SERVICE LETTER

HC-SL-30-246

De-Ice - Spare Parts Release

Hartzell PHC-J3YF-2()/FC7663K-2R aluminum hub, compact propellers installed on Raytheon 58 Barons equipped with propeller de-ice are affected by this Service Letter.

Areas of Damage Figure 1

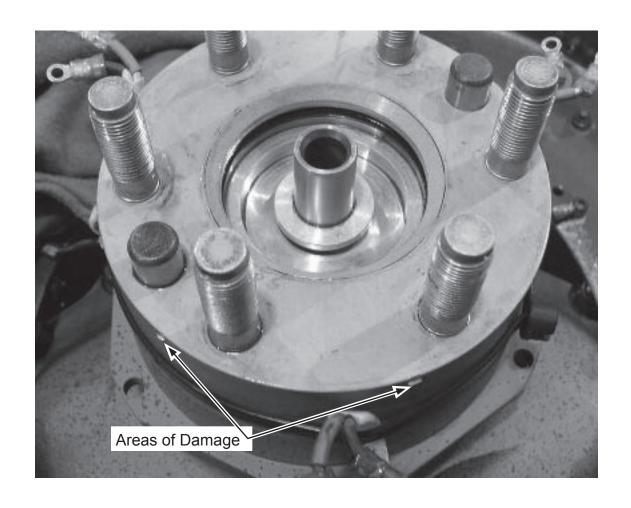
- (1) During the propeller mounting torque inspections in accordance with Hartzell Service Bulletin HC-SB-61-272, damage has been found on the propeller hub.

- Numerous reports have been received concerning the propeller hub damage. Investigation indicates that the damage was caused by contact between the hardware used to attach the slip ring to the de-ice split mounting plate and the propeller hub. The diameter of the hardware specified for attaching the slip ring to the de-ice split mounting plate may be too large resulting in the contact.

- (3) The damage appears as small indentations on the outside diameter of the propeller hub extension surface. See Figure 1.
- (4) New hardware is required for attaching the slip ring to the de-ice split mounting plate. Attachment of the slip ring to the de-ice split mounting plate using the new hardware prevents further damage to the propeller hub.

- (1) This Service Letter introduces new hardware with smaller diameters for attaching the slip ring to the de-ice split mounting plate.
- (2) This Service Letter supplies hub inspection and repair criteria for hub damage.

At next slip ring removal, inspect the hub, rework as necessary and attach the slip ring to the de-ice split mounting plate with the new reduced diameter hardware.

- A. Hub Inspection
 - (1) If no damage to the propeller hub is visible, proceed to Paragraph 3.B.
 - (2) If damage to the propeller hub is visible:
 - CAUTION 1: DAMAGE DEPTH OF 0.020 INCH (0.508 MM) IS PERMITTED

- (a) Lightly file or polish the hub to remove the damage. Raised area must smoothly blend with the undamaged surrounding area and have a depth to width ration of at least 10. Raised material is not permitted. Rework is permitted to a maximum depth of 0.020 inch (0.508 mm) with a surface finish of Ra100 or better.

- (3) If individual damage or rework depth is greater than 0.020 inch (0.508 mm) depth, hub must be retired from service in accordance with the Parts Retirement chapter of Hartzell Standard Practices Manual 202A (61-01-02).
